DATE: April 6, 2022

FROM: Town of Mammoth Lakes Community and Economic Development
Department

RE: Addendum to Environmental Impact Report for Mammoth Yosemite Airport
Terminal Area Development Project Improvements (SCH #2019100384)

EXHIBIT A

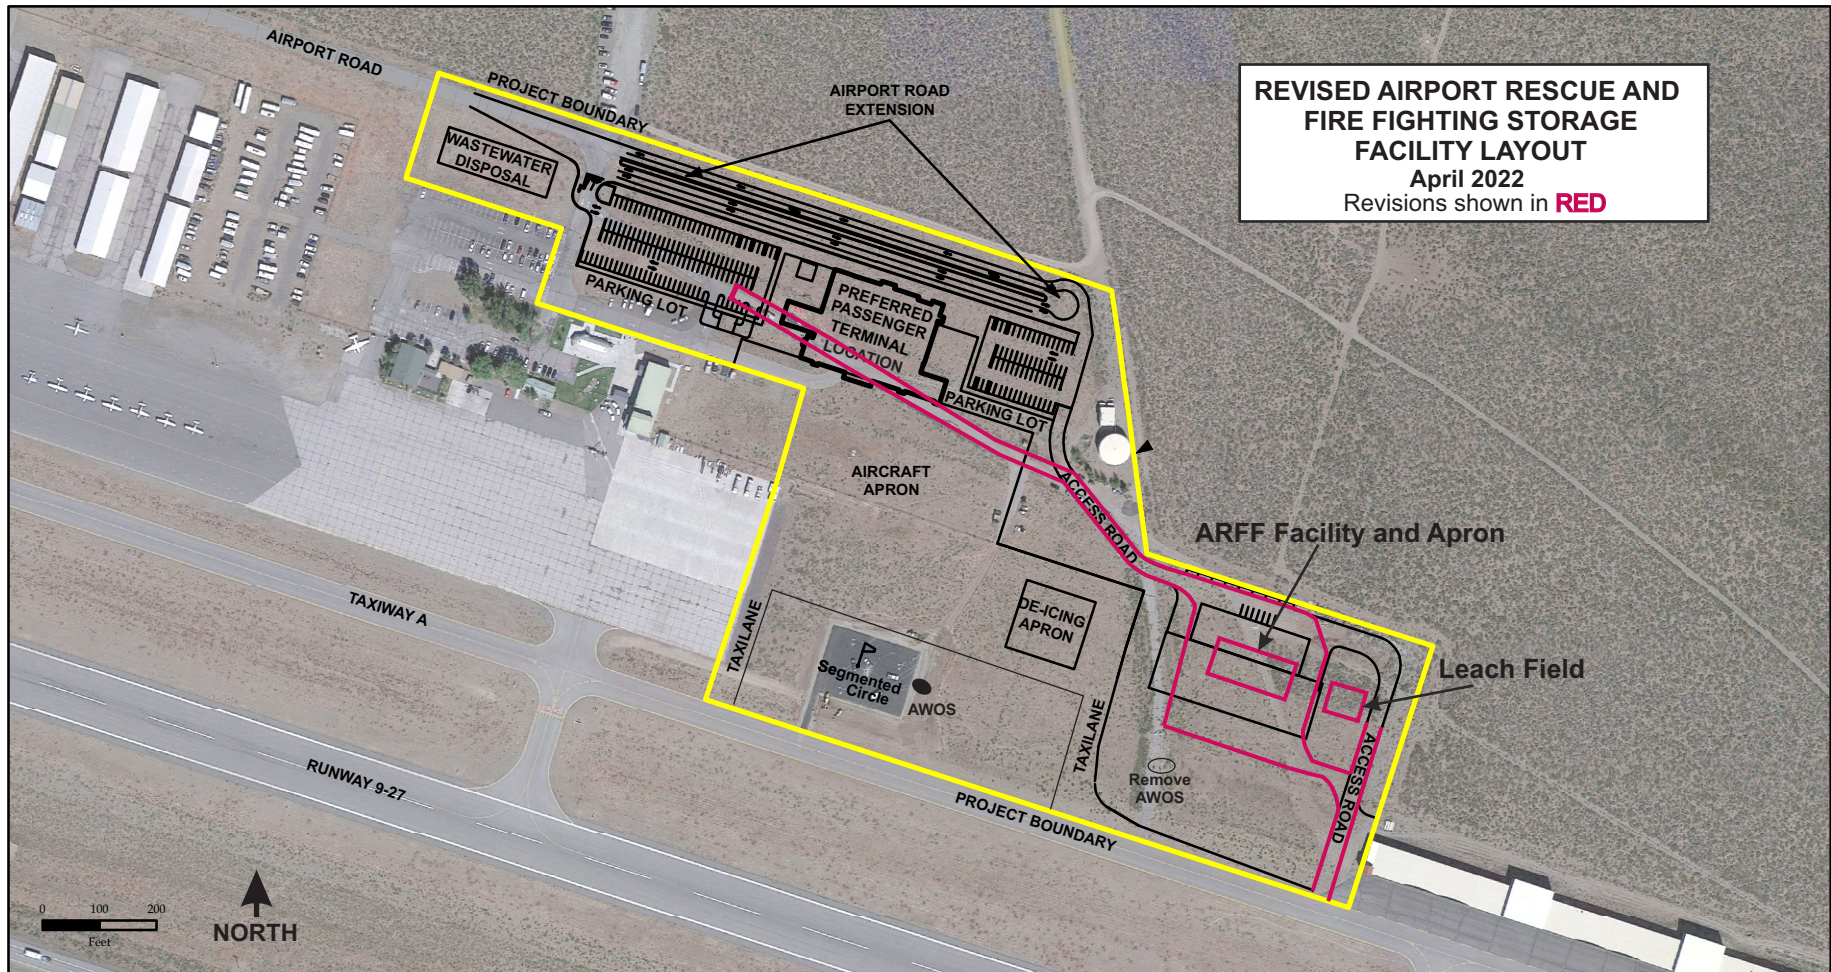
TADP Approved	TADP Proposed Revision
ARFF Building: footprint 8,400 sq. ft.	ARFF Building: footprint 10,350 sq. ft.
Apron and parking: approximately 3,300 sq.yds.	Apron and parking: approximately 3,900 sq. yds.
Access Road: approximately 800 feet	Access Roads: 1,700 feet
Leach Field: Not specific to ARFF	Leach Field: For ARFF only

The modified ARFF facility, apron and parking area, and access road are located within the original approved project area. The access road has been lengthened, but this involves repaving an existing road to serve the ARFF facility. A sanitary leach field was originally proposed near the passenger terminal building; it is now proposed adjacent to the ARFF facility. Based upon a groundwater study, the proposed leach field would be downgradient of two water wells which serve the airport.
